SAFETY EVALUATION BY THE OFFICE OF NUCLEAR REACTOR REGULATION

APPENDIX J REVIEW

DUANE ARNOLD ENERGY CENTER

TECHNICAL EVALUATION REPORT

Figure 1.

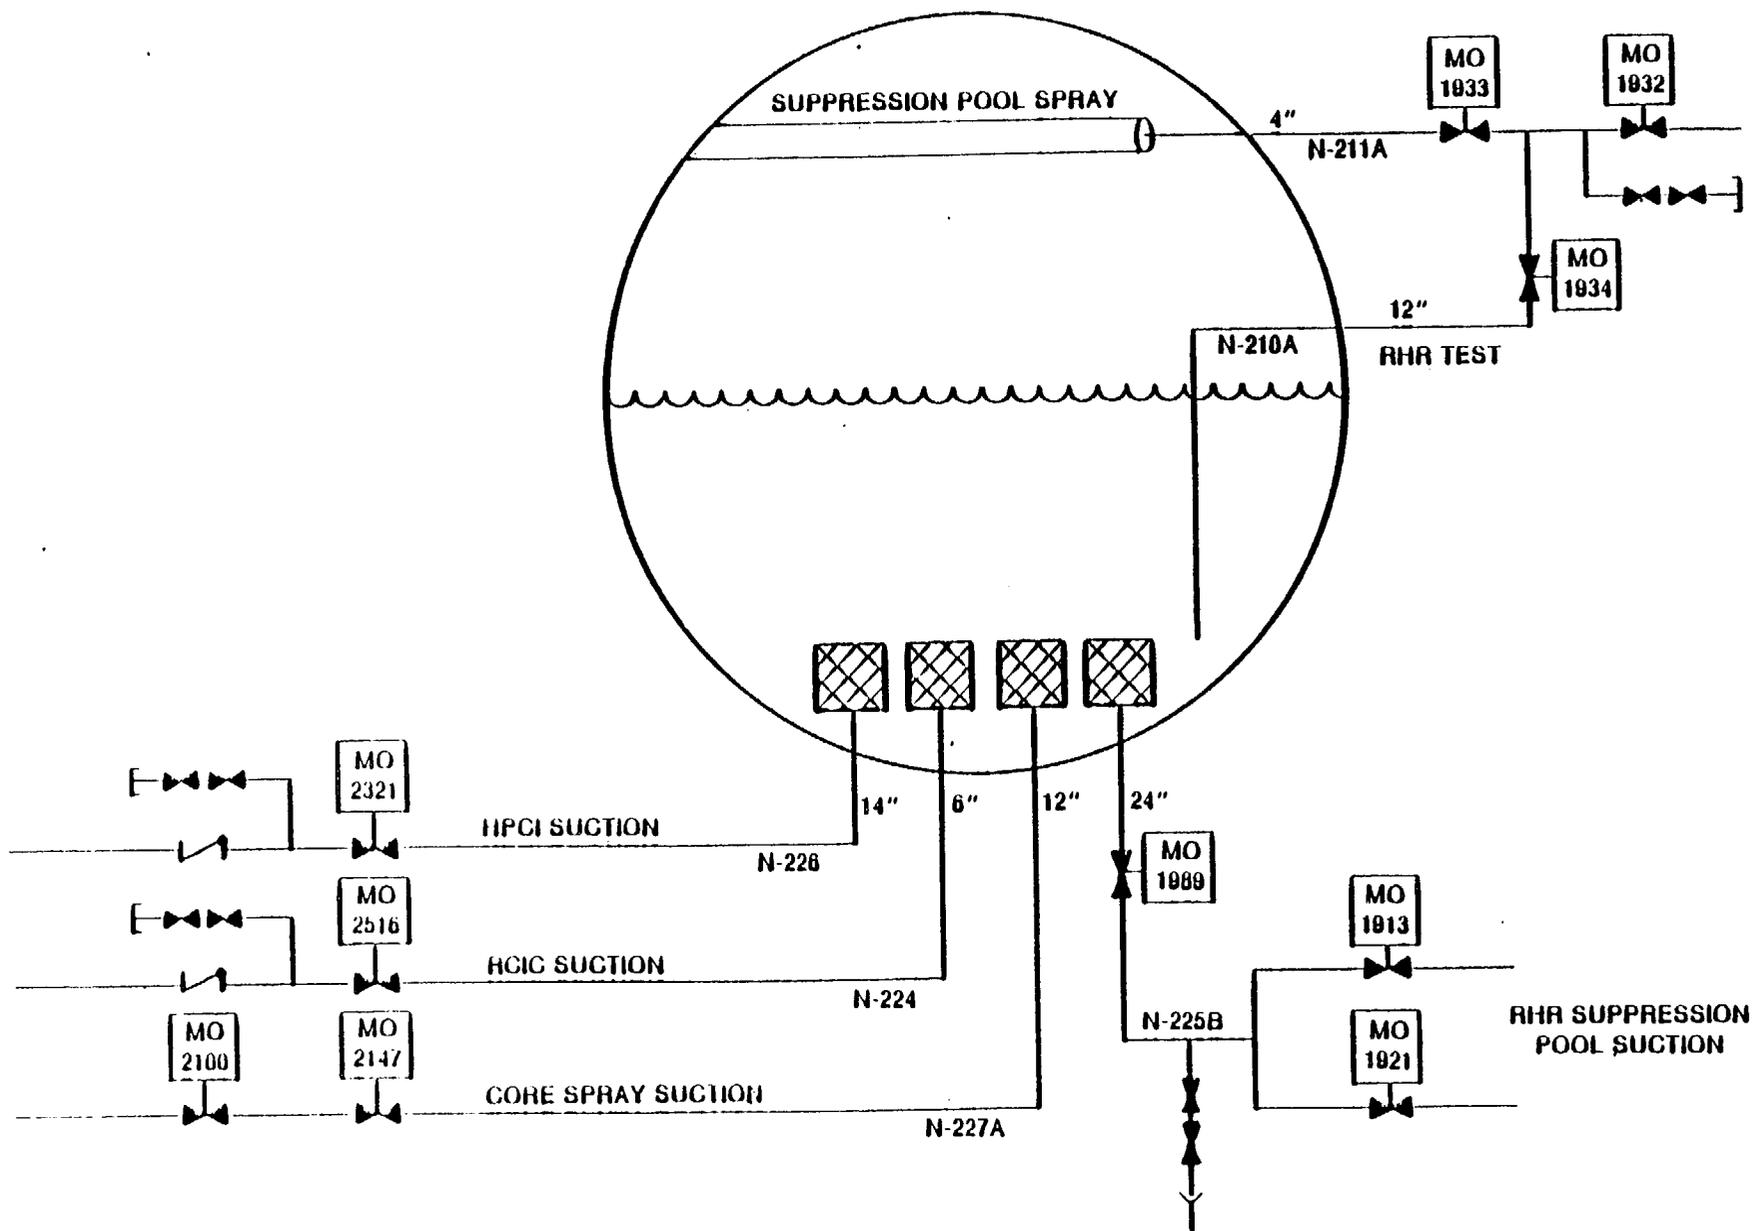
The piping configurations of concern are presented in Figures 1 and 2. Figure 1 shows the HPCI, RCIC, and core spray suction lines and one loop of the suction, suppression pool spray, and RHR test lines. Figure 2 shows one loop of LPCI injection, RV head spray, and containment spray. As can be seen in Figure 1, the HPCI, RCIC, core spray, and RHR suction lines are isolated from the containment atmosphere by the water level in the suppression pool. Since these lines are continuously water filled in a post-accident condition,

the isolation valves are not relied upon to prevent the escape of containment air to outside atmosphere; therefore, Type C testing is not required by Appendix J. Similarly, because the RHR test line terminates below the level of the pool, its isolation valve is also isolated from containment atmosphere, and Type C testing of this line is not required.

In summary, Type C testing is not required and no exemption is necessary for the following penetrations because Appendix J does not require testing: N-210A & B, N-224, N-225A & B, N-226, N-227A & B, and X-17. For penetration X-39A & B, the inboard isolation valves should be tested in the direction of accident pressure or by pressurizing between the inboard and outboard isolation valves in order to test the valve packing and body-to-bonnet seals of the inboard valves. For penetration N-211A & B, the inboard isolation valves should be tested in the direction of accident pressure or by pressurizing

Figure 2.

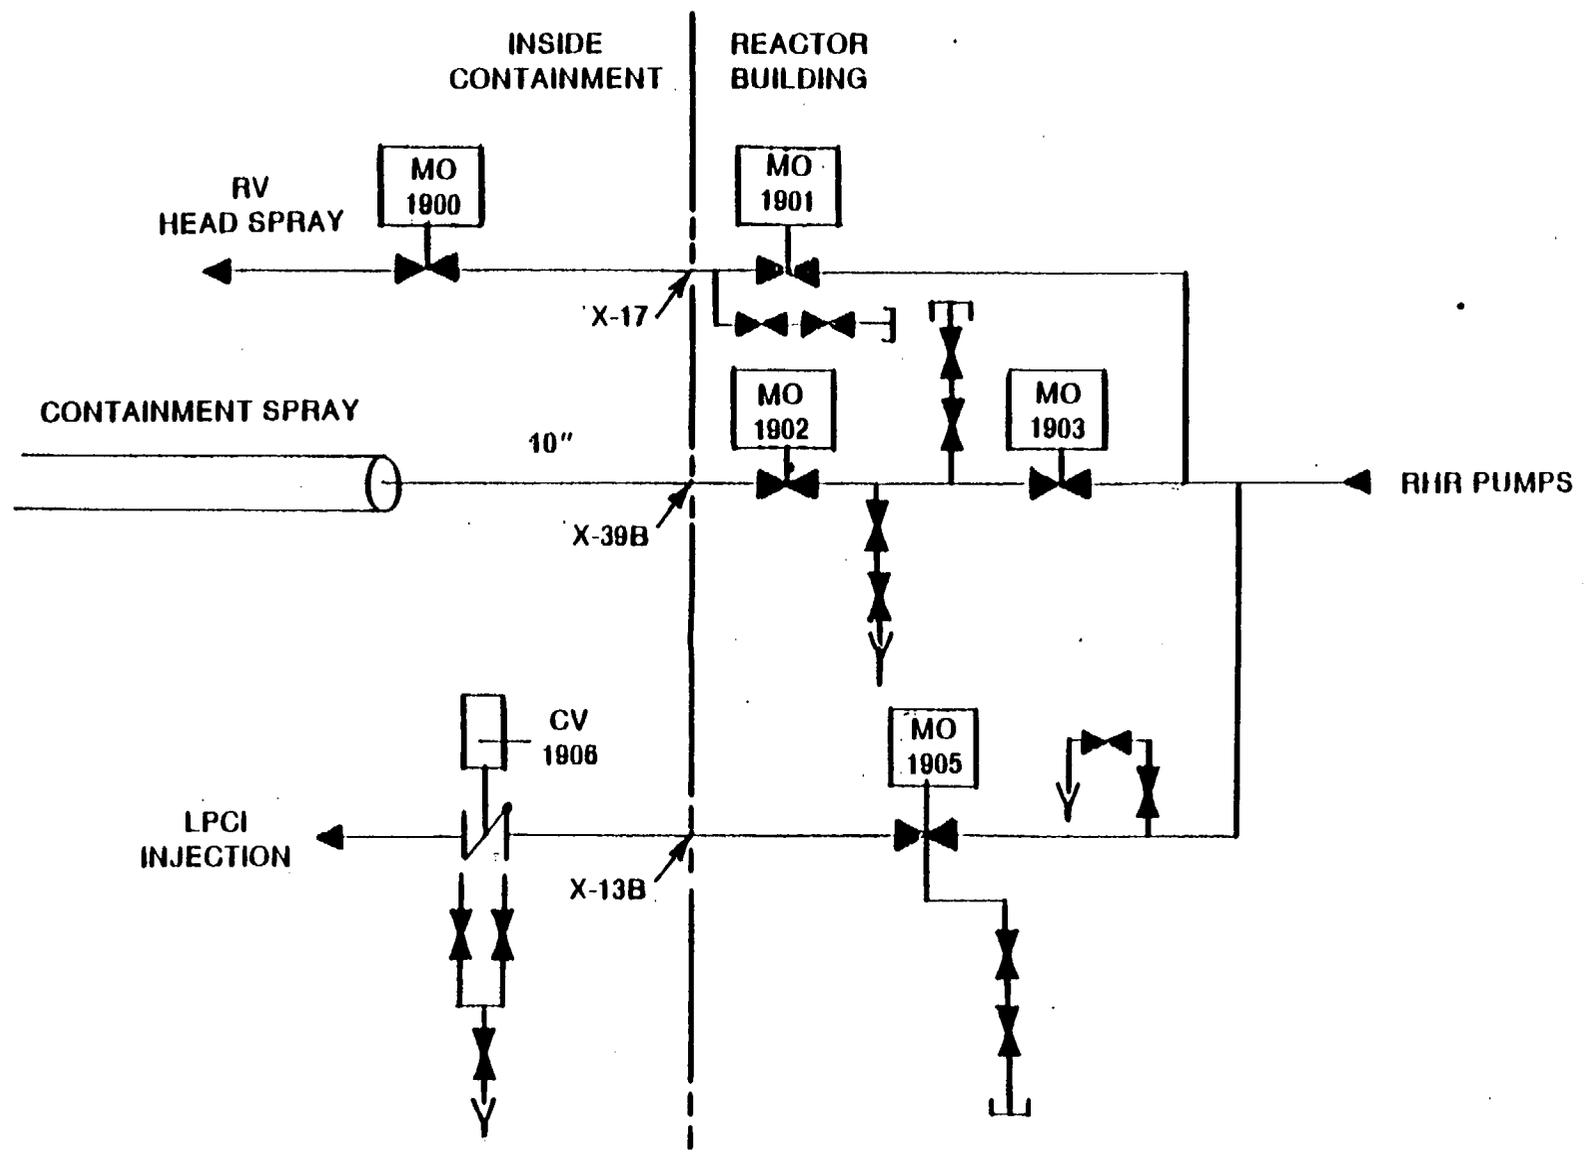
The LPCI injection line will be normally open and filled with water at a pressure greater than containment accident pressure as soon as safety injection is initiated. Furthermore, should valve MO-1905 (Figure 2) fail to open, the valve will be water sealed by RHR water at pump head pressure, and no single active failure can cause a loss of this pressure. Since MO-1905 is a gate valve, the water pressure will unseat the upstream valve disc and pressurize the valve packing and body-to-bonnet seal area with water. Consequently, there is no path for containment air leakage to the atmosphere through this line, even in the case of air leakage past the seat of check valve CV-1906. Therefore, this line is not a potential source of containment atmosphere leakage and the isolation valves are not required to be Type C tested in accordance with Appendix J.

Unlike the LPCI injection line the remaining three lines (suppression pool spray, containment spray, and RV head spray) are not automatically initiated by safety injection. Flow in these lines is left for manual initiation, if necessary, once sufficient reactor vessel level has been reestablished. Depending upon the severity of the accident, flow in these lines may not be established (particularly containment spray and suppression pool spray). Furthermore, at the start of an accident, there is no guarantee that there is any water in the line between the inboard and outboard isolation valves. In the case of these lines, therefore, there is a potential for containment air to escape to the outside atmosphere through the valve packing or body-to-bonnet seal area of the inboard isolation valve, even though the outboard valve is water sealed, as described in the case of valve MO-1905 of the LPCI injection line.

In the case of the reactor vessel head spray line, the inboard isolation valve is located inside containment (e.g., valve MO-1900). Leakage through the valve packing or body-to-bonnet seal is not a concern since any leakage is

For both the containment spray line and the suppression pool spray lines, however, the inboard isolation valves are located outside containment (e.g., valves MO-1902, MO-1933, MO-1934). If any of these valves leak through the packing or body-to-bonnet seals, the leakage of containment air reaches the outside atmosphere. Consequently, Appendix J requires that these valves be Type C tested. However, since the packing and body-to-bonnet seals are the only potential sources of leakage, the testing may be limited to these particular areas. Valve MO-1902 in the containment spray line is also a gate valve. Testing this valve by pressurizing between valves MO-1902 and MO-1903 achieves the intent of Appendix J because this test will unseat the upstream disc of valve MO-1902 and will pressurize the area of concern. Valves MO-1933 and MO-1934, however, are globe valves. FRC does not have sufficient information to determine whether the packing area is isolated from the containment side of the line when the valve is shut. However, assuming this is the case, these valves may also be tested by pressurizing between valves MO-1932, MO-1933, and MO-1934 since the area of concern will be subjected to the test pressure. If this is not the case, valve MO-1933 must be tested in the direction of accident pressure (note: by pressurizing between the three valves, MO-1934 is tested in the direction of accident pressure since its function in this case is to isolate the suppression pool spray line rather than the RHR test line).

between the inboard and outboard valves provided that this testing will expose the packing and body-to-bonnet seal areas of the inboard valves to the test pressure.
